REMARKS

1. The Examiner has objected to the drawings under 37 CFR 1.83(a).

FIG.3

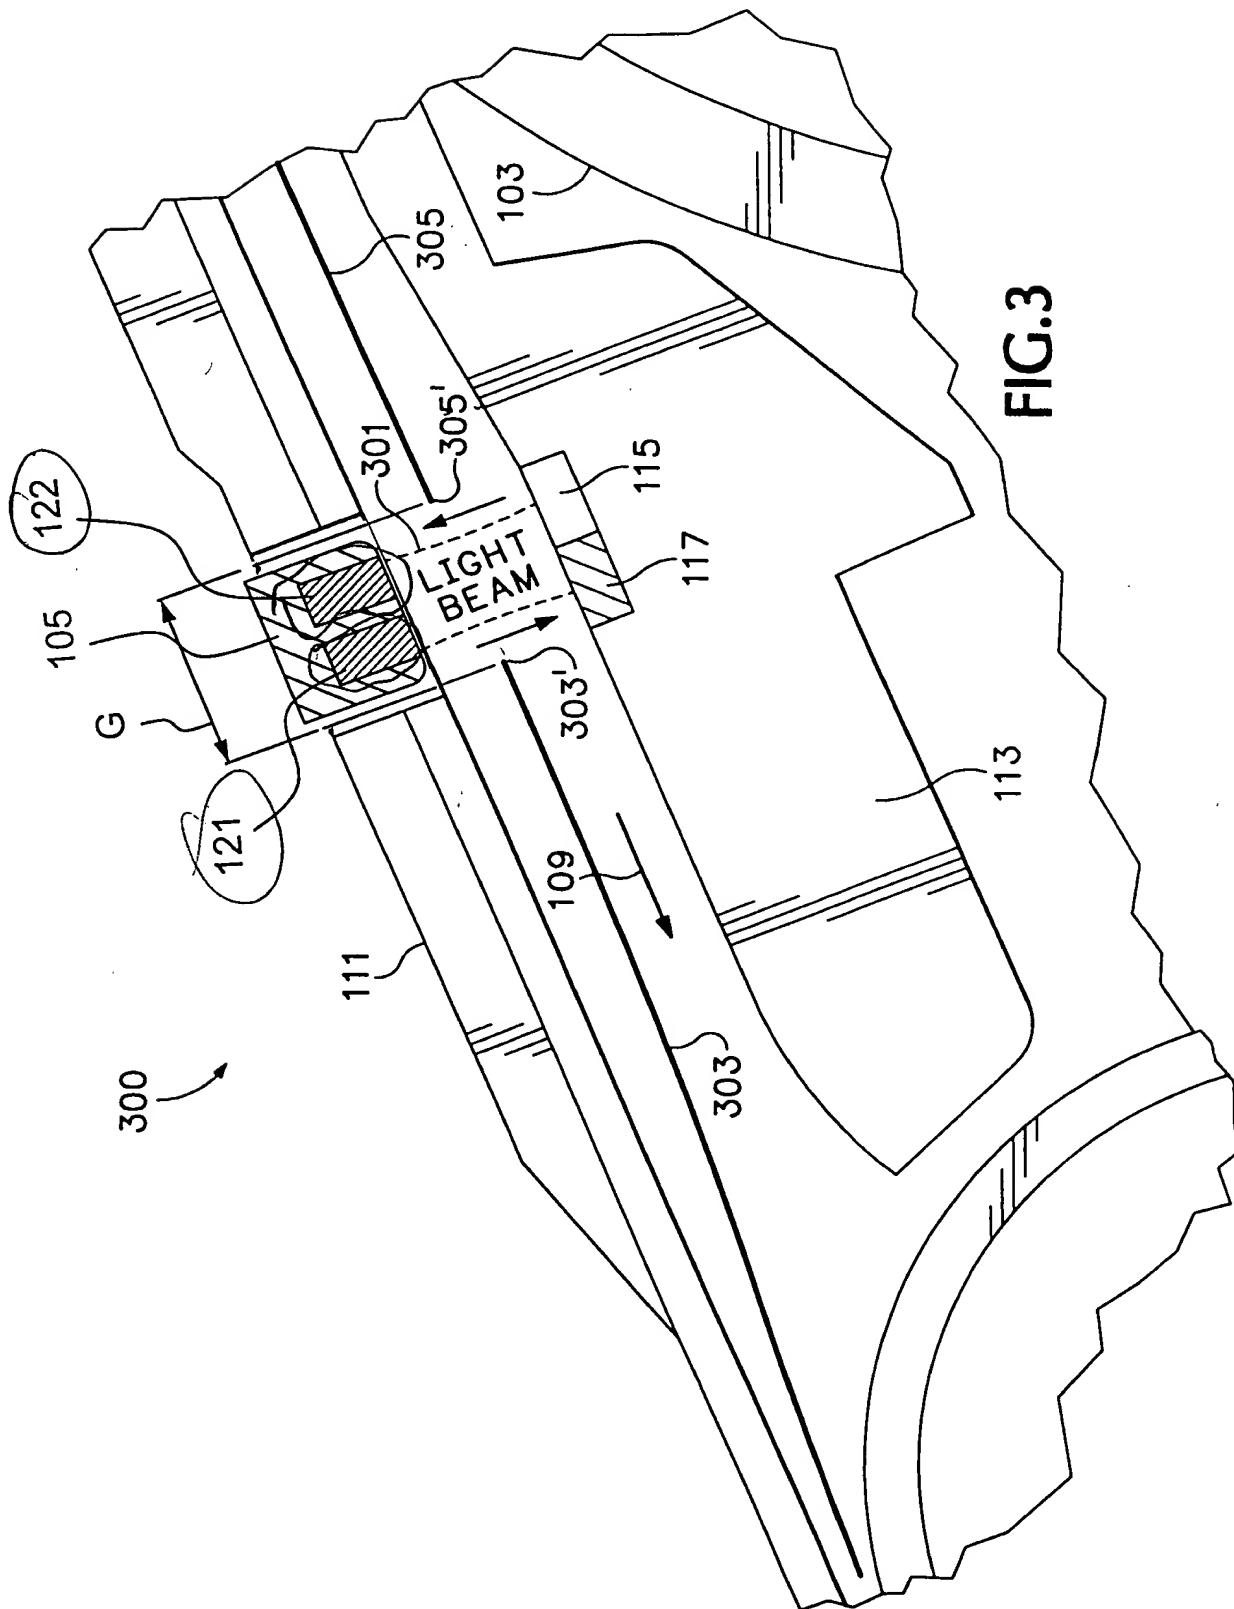
A proposed amended Figure 3 is submitted with this paper. The proposed change shows the light emitter 121 and the light detector 122 as called out in claims 9 – 13. No new matter is added. The amendment is consistent with the description found at paragraph XXIII which provides:

The "hard copy apparatus structure" is recited as element 300 in paragraph XXV of the specification and is shown in Figure 3.
